PLANNING & ZONING CASE NO. SP2024-011

SITE PLAN

PROJECT NUMBER: SP2024-011
PROJECT NAME: Amended Site Plan for 1220 Data Drive
SITE ADDRESS/LOCATIONS: 1220 DATA DR, ROCKWALL, 75032

CASE NUMBER: SP2024-011; *Amended Site Plan for 1220 Data Drive*

1 SITE PLAN

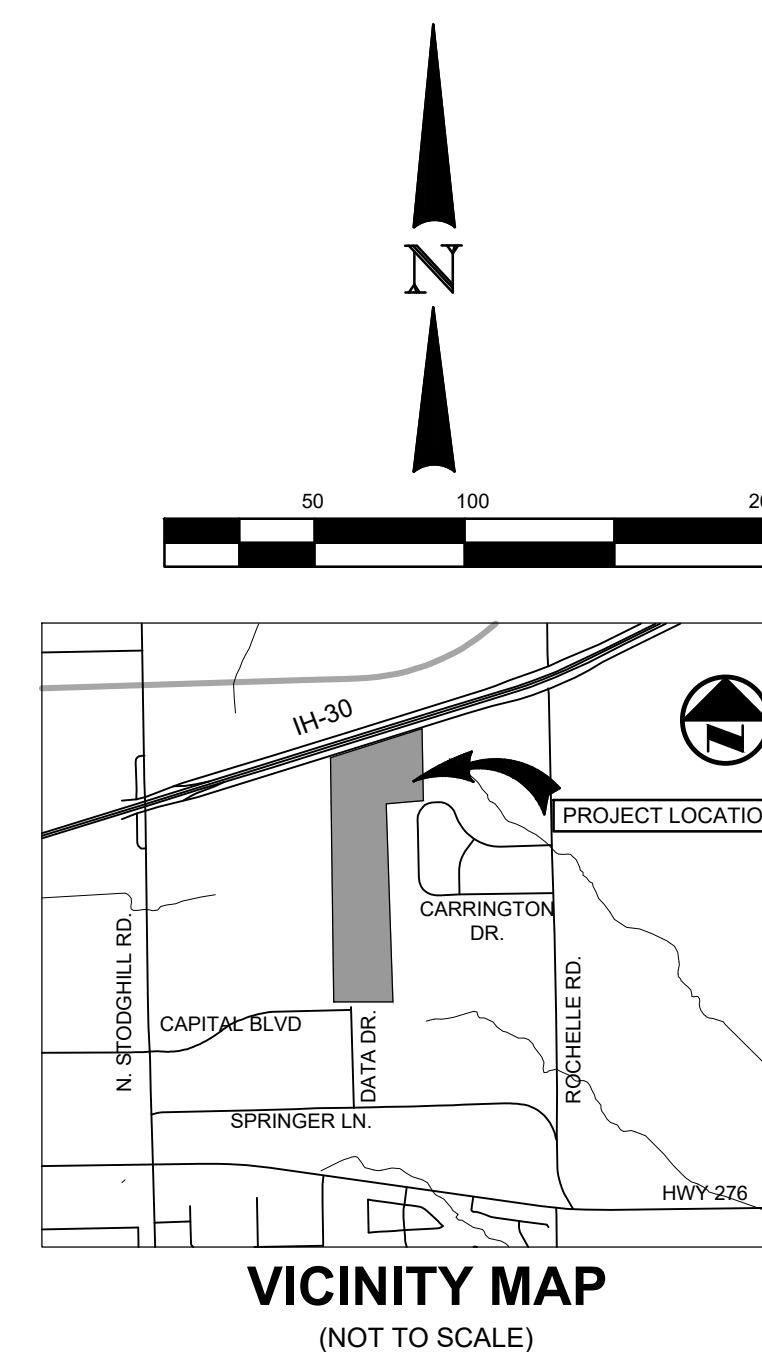
M.6 Site Plan
(1) Please provide the project data table that can be found on the site plan of the previously approved case, SP2021-027. (Subsection 03.04. B, of Article 11, UDC)
(2) There appears to be a future proposed chiller located within a fire lane. Please move this chiller as it may not be located within the fire lane. (Subsection 01.05. C, of Article 05, UDC)

03/21/2024: 1. Is the existing parking bay here being removed? This does not match what was built in the field.

3. No structures will be allowed in easements

1 EXISTING BUILDING 1
PARTIAL EAST ELEVATION
SCALE: 1/16"=1'-0"

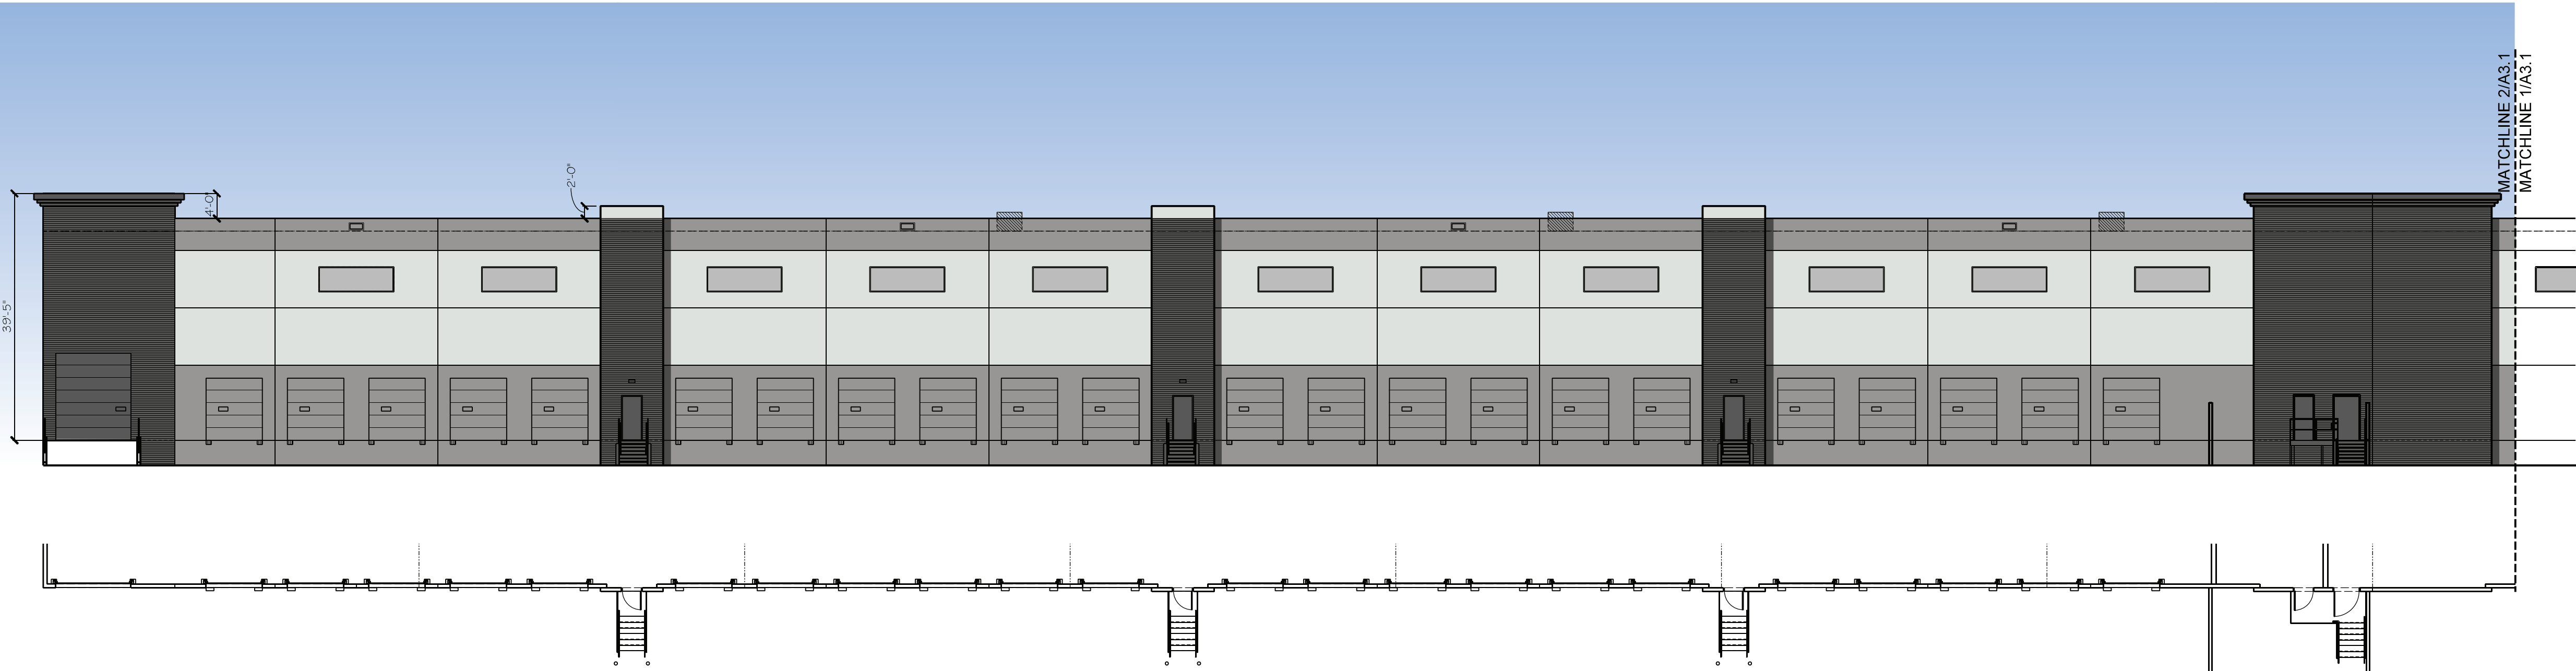
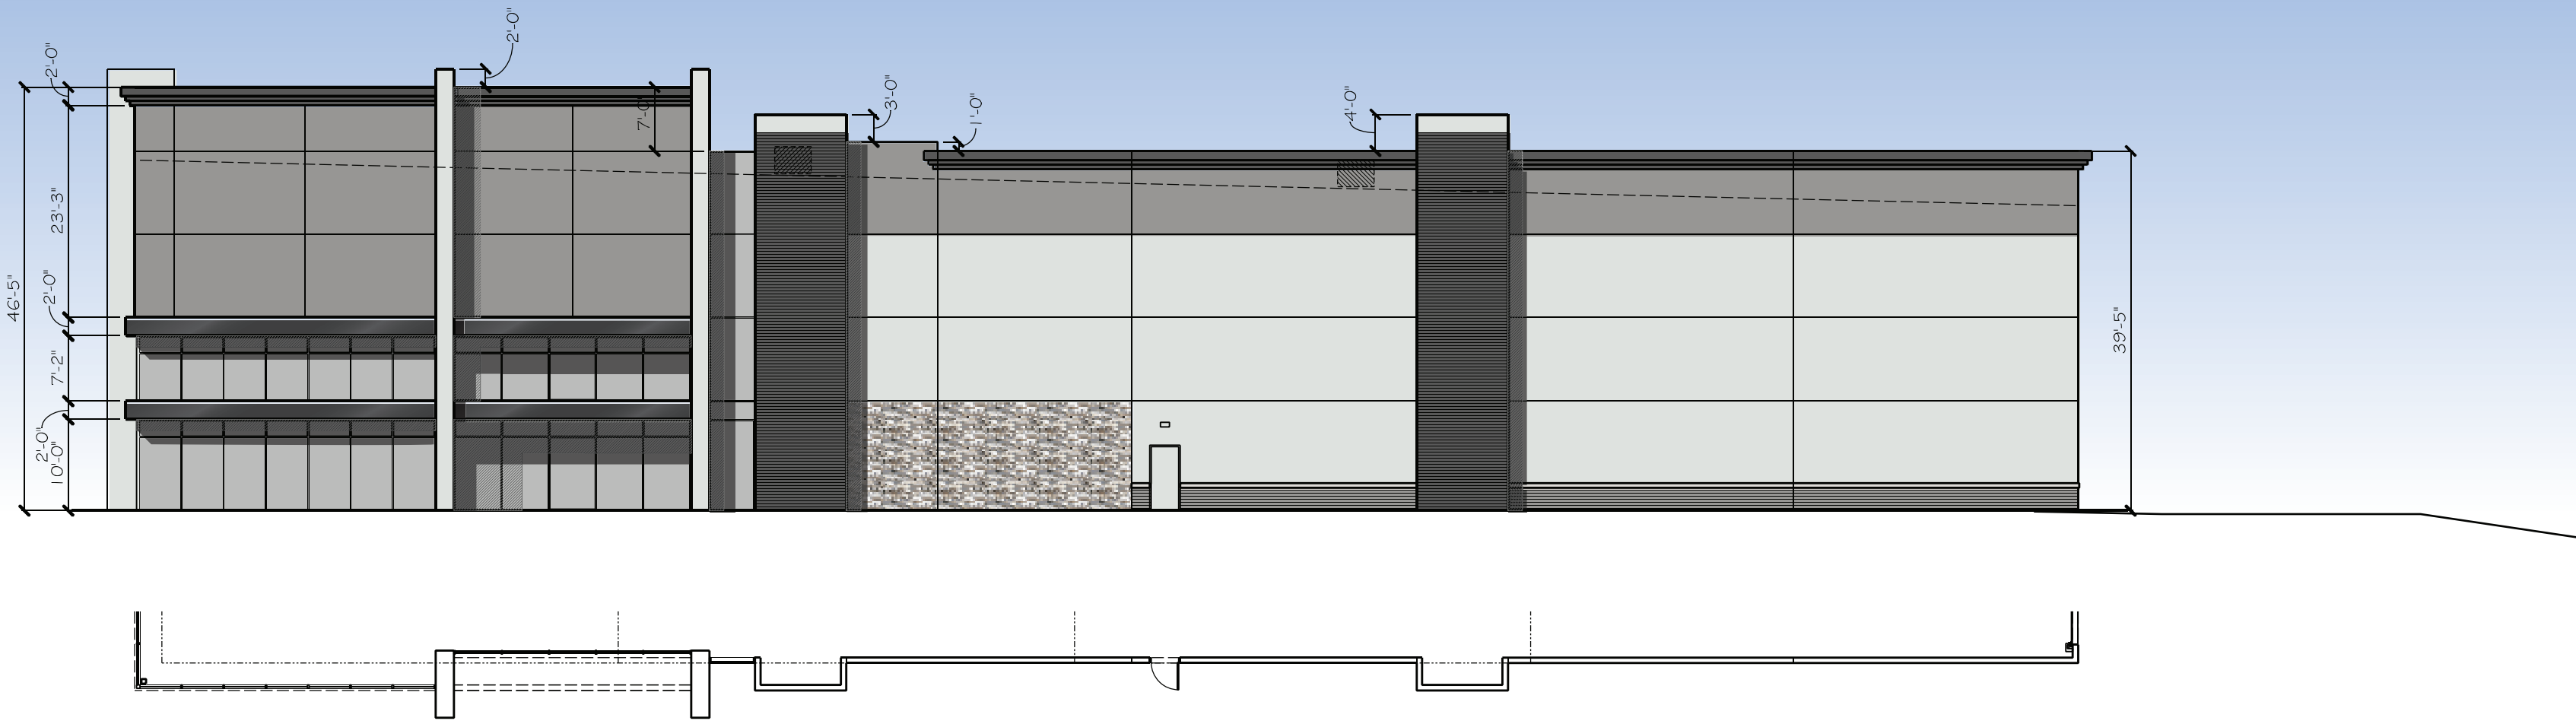
- (1) Please clarify if the silos are to be painted or finished in a non-reflective coating to reduce glare and mitigate visibility. (Subsection 01.05. D, of Article 05, UDC)
- (2) Please ghost the silos in elevations where they are in the background. (Subsection 01.05. D, of Article 05, UDC)

LANDSCAPE PLAN
(CITY CASE NO. SP2024-011)
SEEFRIED ROCKWALL
11.126 ACRES AND 11.108 ACRES BEING SITUATED
IN THE R.B. IRVINE SURVEY, ABSTRACT NO. 120
CITY OF ROCKWALL, ROCKWALL COUNTY, TEXAS

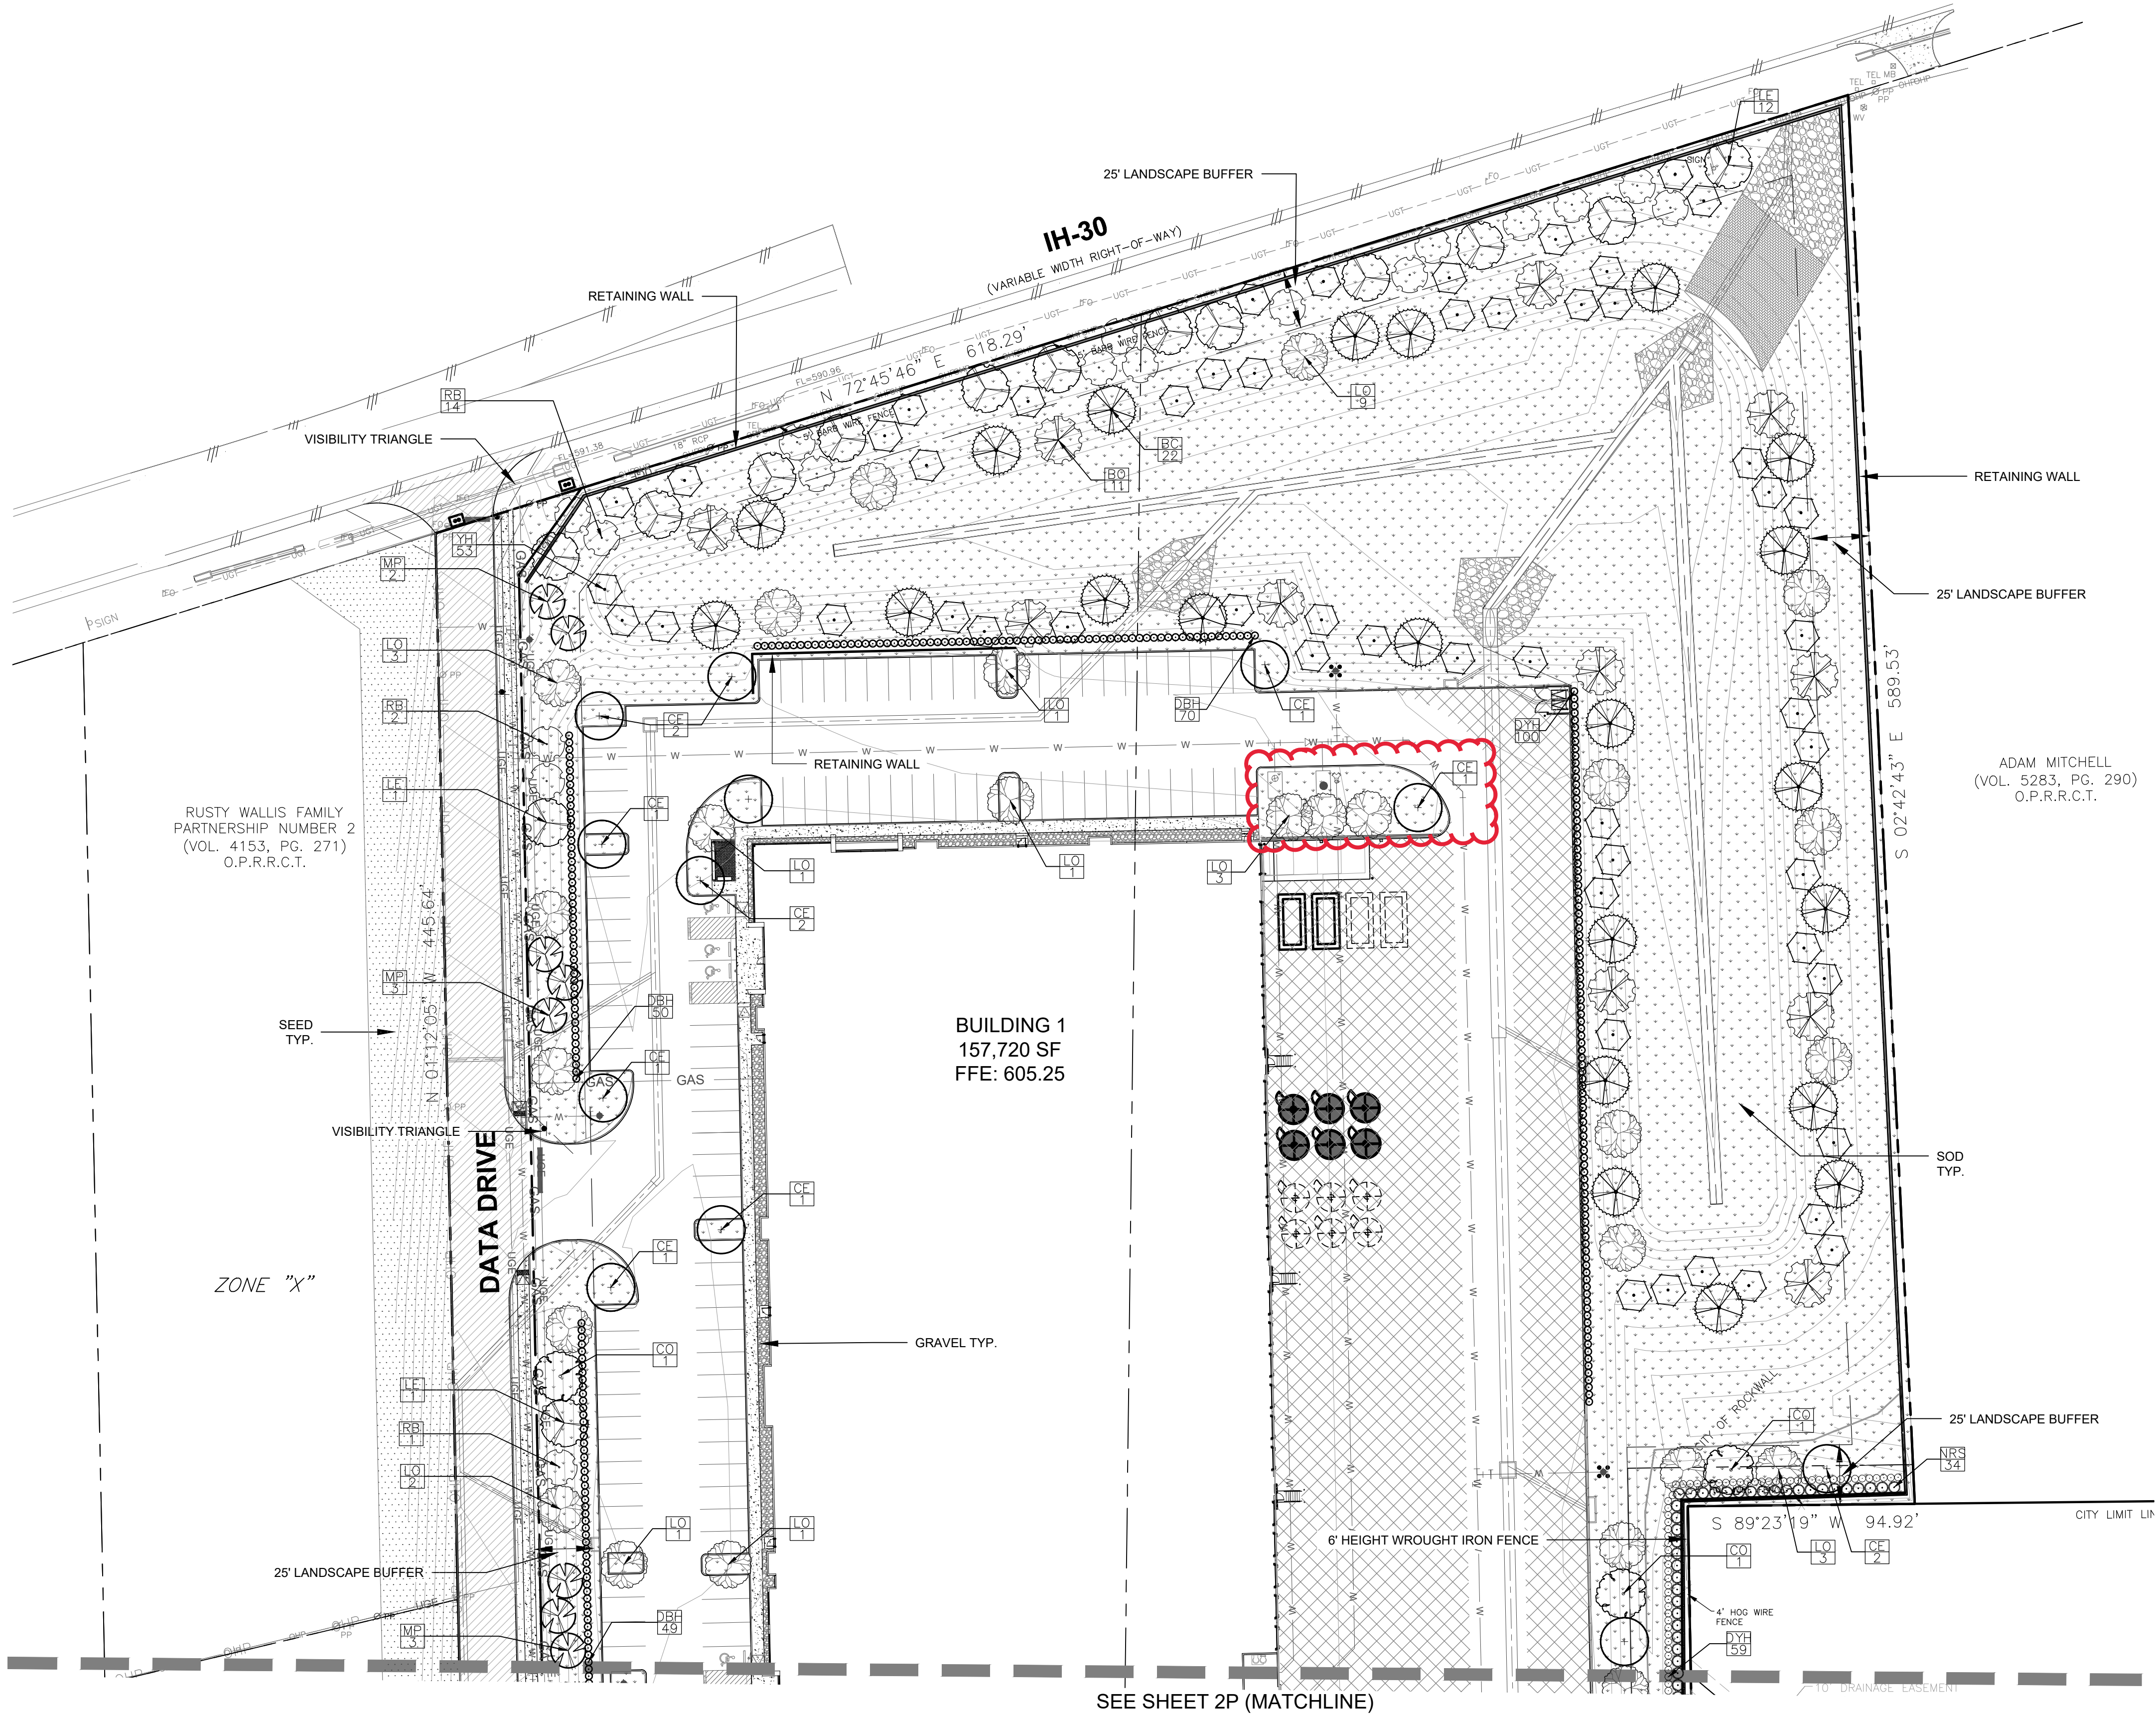
(1) Please provide an updated landscape plan, as the chillers and silos will need additional landscape screening. According to Subsection 01.05. D, of Article 05, of the Unified Development Code, Aboveground Storage Tanks shall require primary (i.e. screening wall) and secondary (i.e. landscaping) screening. In this case, only the wall is being proposed. Staff would recommend the use of large evergreen canopy trees adjacent to the wall and between the drive and detention pond east of the proposed silos. (Subsection 01.05. D, of Article 05, UDC)

03/18/2024: Please provide and landscape plan with plant legend
